FINAL ENVIRONMENTAL IMPACT REPORT

**CITY OF SACRAMENTO**

BIKEWAY MASTER PLAN  
AMENDMENTS

**VOLUME II: CITY OF SACRAMENTO BIKEWAY MASTER PLAN: COMMENTS, RESPONSES TO COMMENTS, AND MINOR CHANGES/EDITS**

*Figure 2-2* Deleted the West River Drive segment (#18) from the South Natomas area.

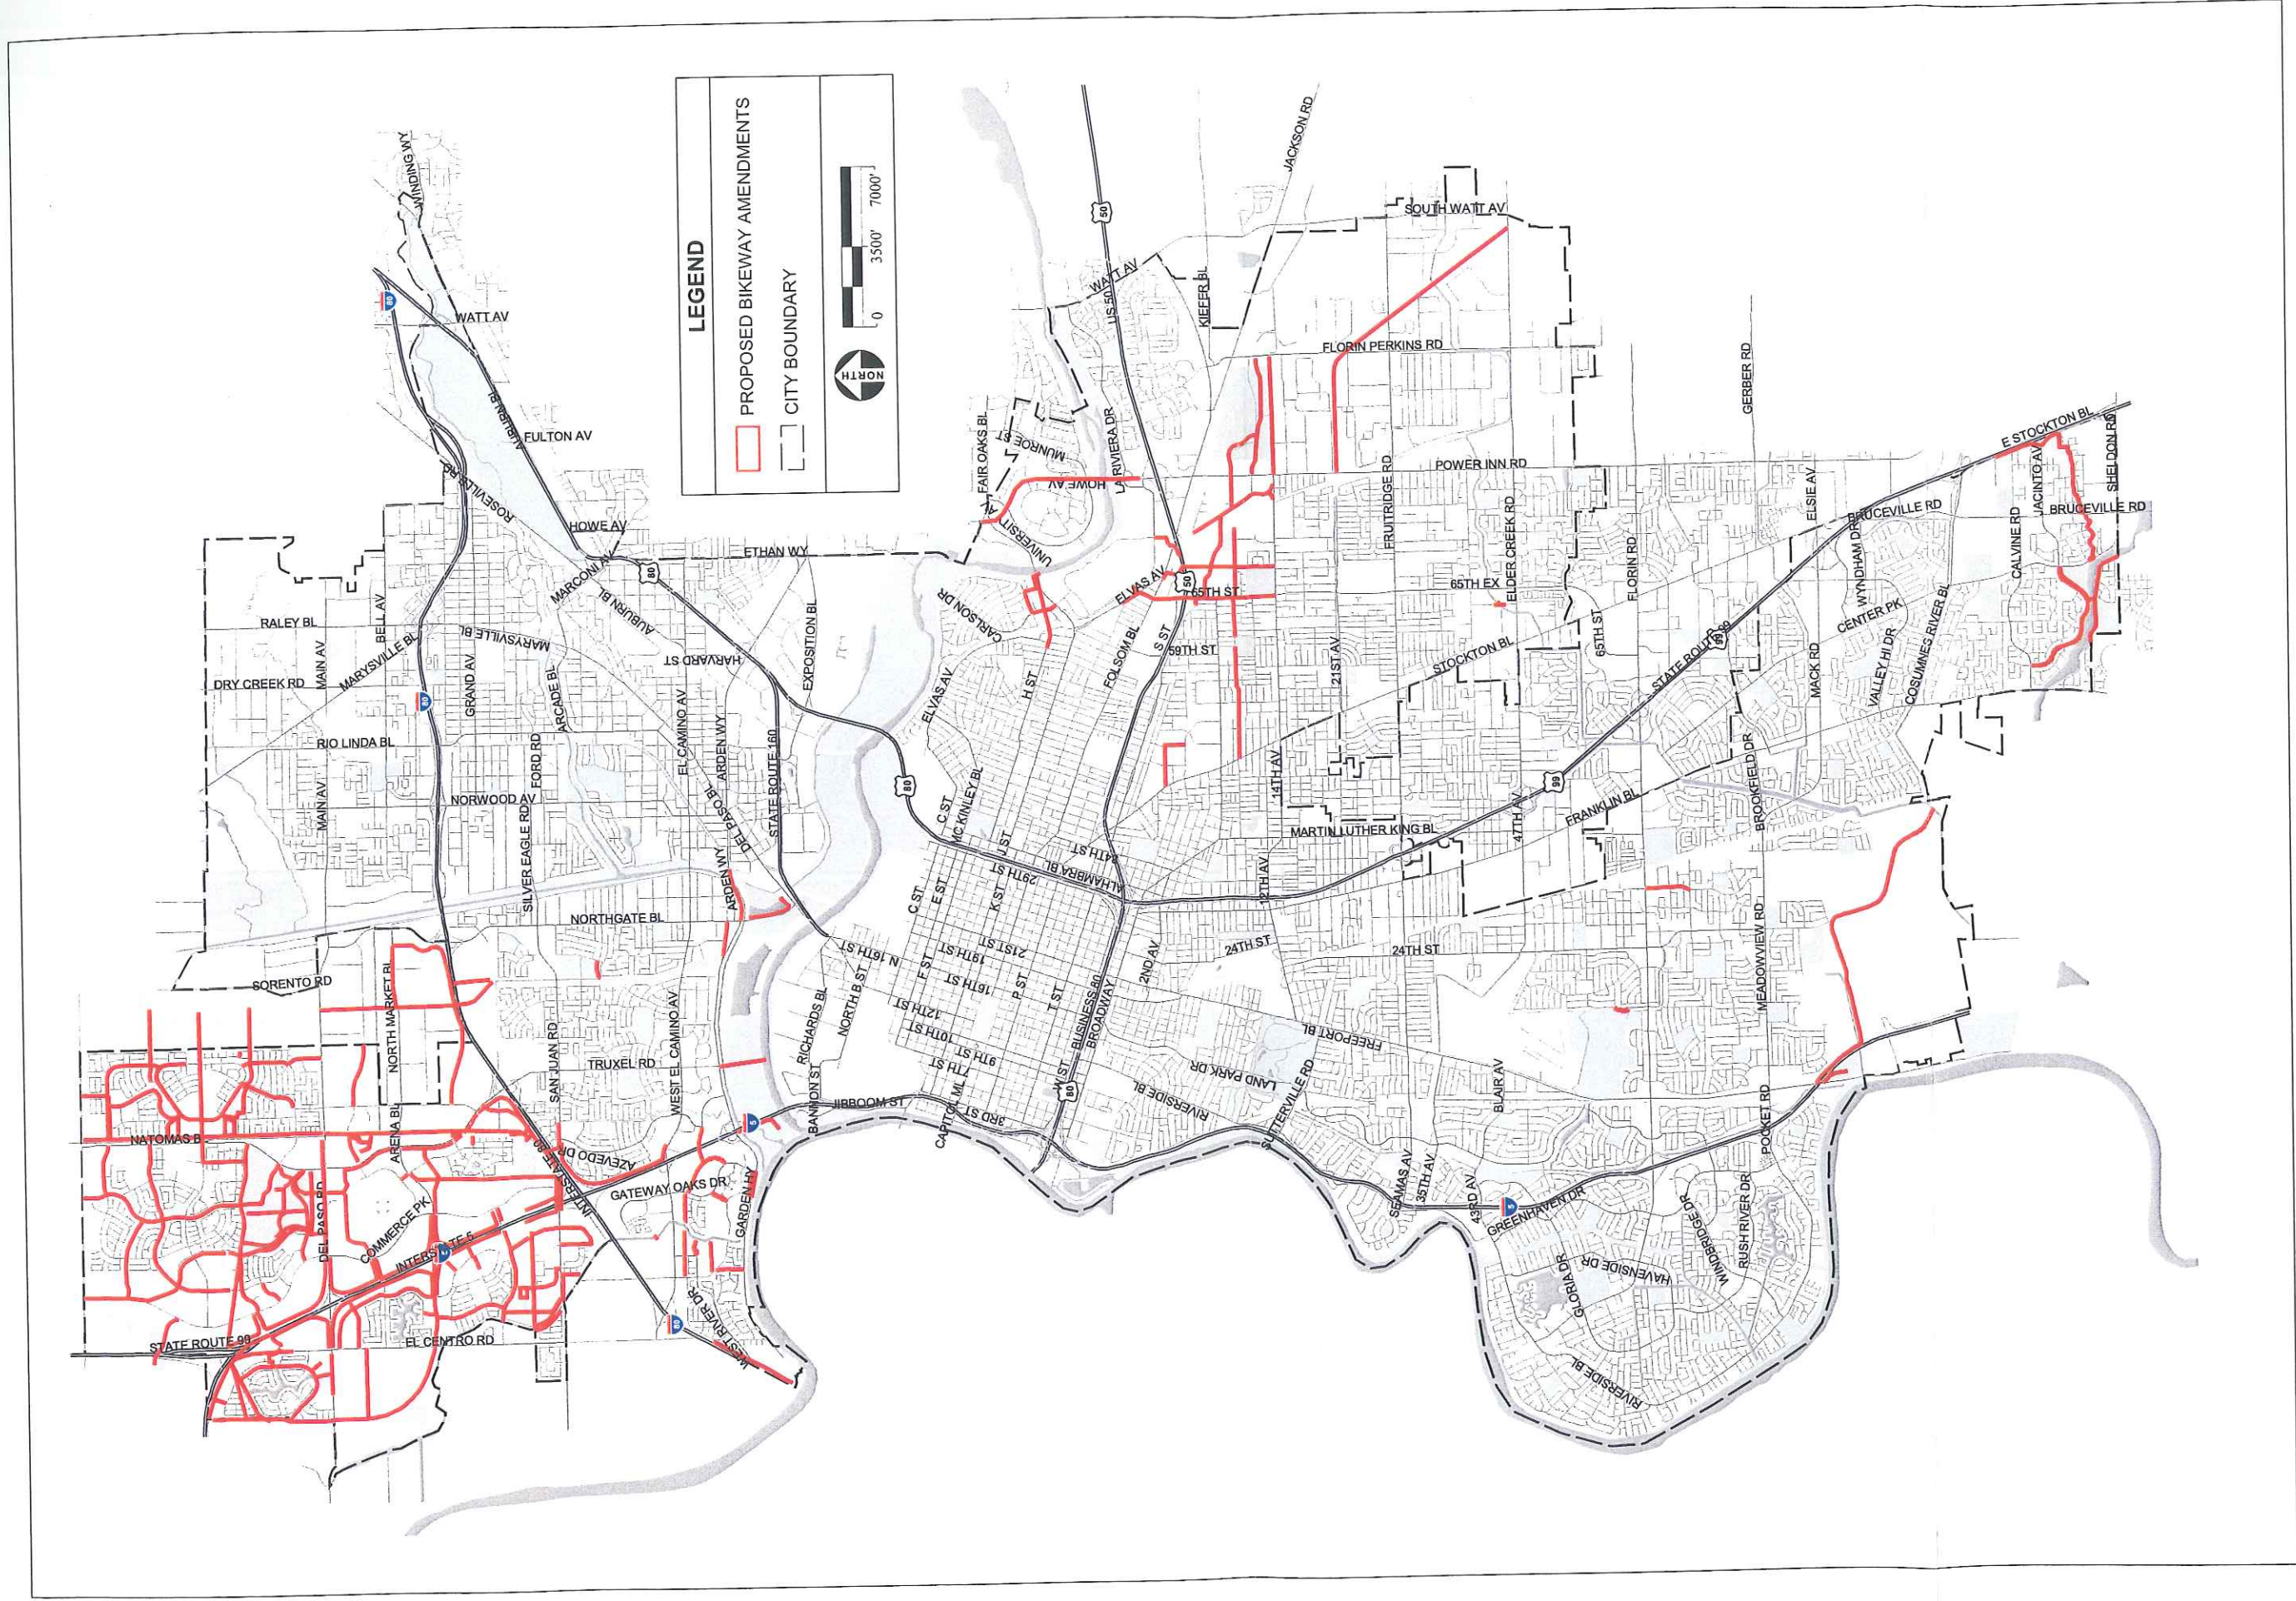
The commenter suggests the on-street bike path addition along West River Drive should connect to Shady Arbor Drive. The segment shown on the map in the DEIR (Figure 3-6, Segment #18) shows the on-street bike lanes terminating at Barandas Drive. Resolution 95-160 and 95-166 for the Bikeway Master Plan adoption shows West River Drive as being included. Therefore, it is not necessary to include West River Drive and the EIR will be modified to exclude this segment (Figure 3-6, Segment #18).

*Figure 3-6* The West River Drive segment (#18) was deleted from the figure and the numbering revised accordingly. Also, the figure has been revised to indicate the existing bridge crossing the Main Drainage Canal.

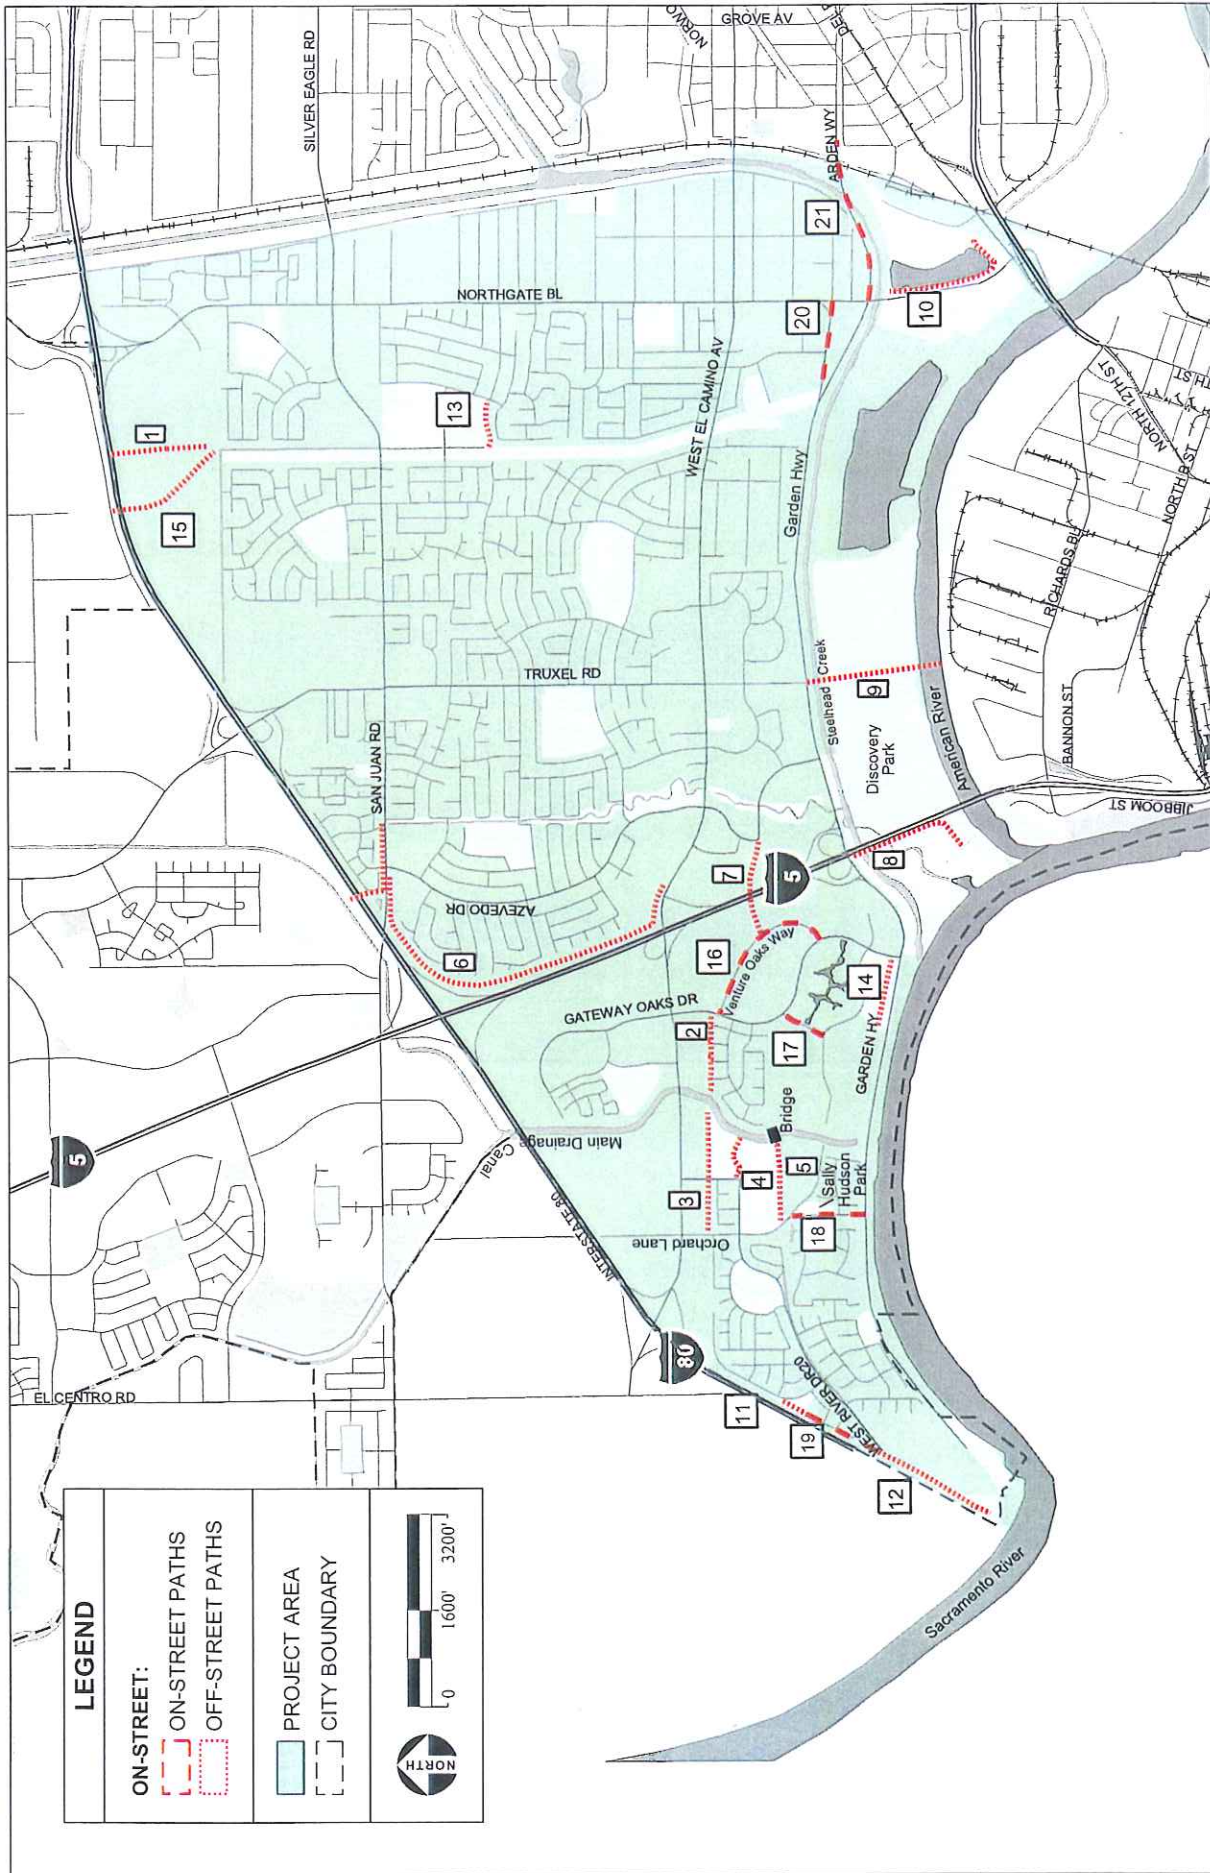
1-4  Item 8 – Further information is needed regarding figure 3.6, #5 depicting an off-street bikeway from the Main Drain to Sally Hudson Park. It appears this should be an on-street application, running along River Plaza Drive.

1-5  Also, there needs to be a continuation of the Main Drain to Orchard bikeway, figure 3.6 #3 illustrating continuation to Barandas Drive, figure 3.6 #12/20

The commenter requests clarification of new off-street trails (3) crossing the canal. The trail under consideration (DEIR, Figure 3-6 #3) currently is not specific enough to indicate a canal crossing. The crossing of the canal can be accomplished at the existing bridge south of the trail by linking to trail Segment #5 along the adopted planned trail that runs from West El Camino Avenue parallel to the canal on its west bank. Information on adopted bikeways is excluded because only amendments to the existing adopted bikeways are being considered.

The commenter requests clarification regarding figure 3.6, #5 depicting an off-street bikeway from the Main Drain to Sally Hudson Park. It appears this should be an on-street application, running along River Plaza Drive. The map illustrates an off-street bikeway, which would run east-west between the Main Drain and Orchard Lane in the open space south of Leroy Greene Middle School. No on-street bikeway for this alignment is proposed.

The commenter suggests the continuation of the Main Drain to Orchard bikeway in figure 3.6 #3 illustrating continuation to Barandas Drive and figure 3.6 #12/20. The existing Bikeway Master
